Direct audio connection for WIA broadcasts

Version for all MB8719 / MB8734 SSB radios

STN 1996 / 2001 / 2013

PA switch - rewired

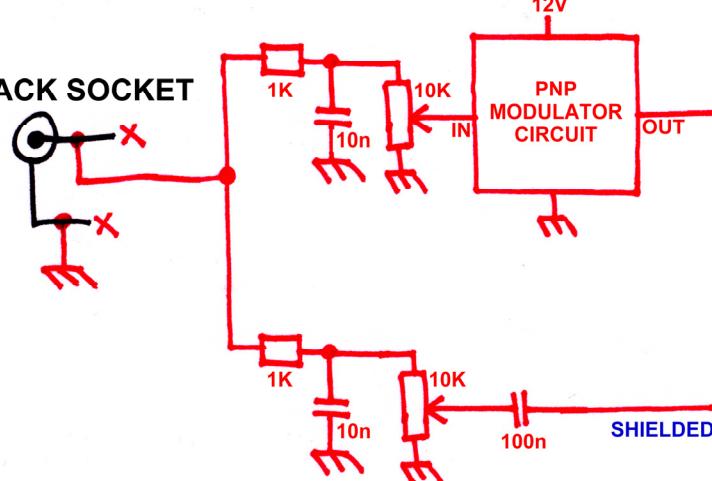
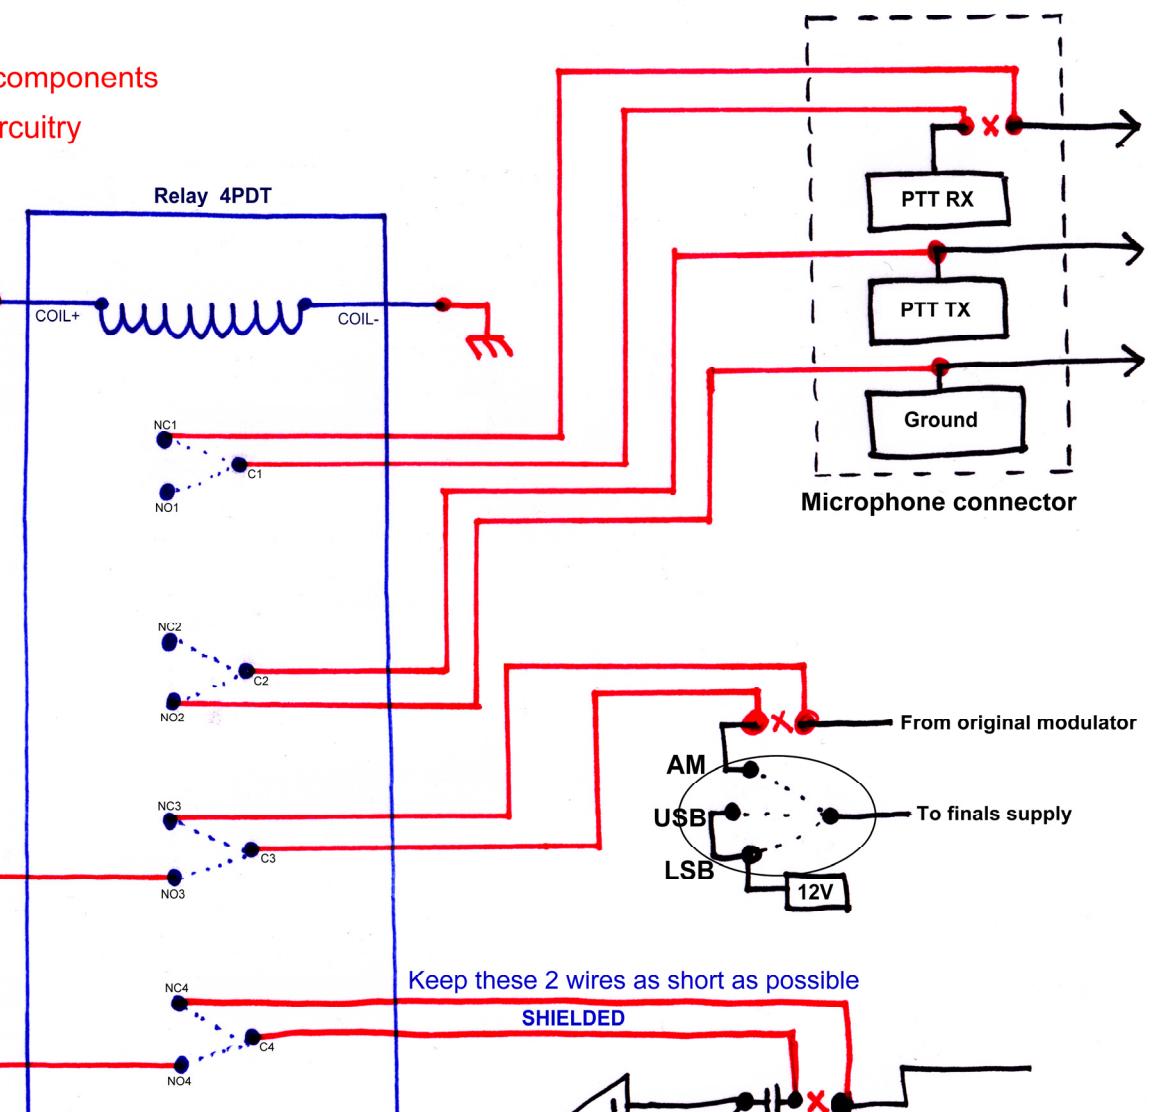
BLUE = added relay

RED = added wiring and components

X = cut made to original circuitry
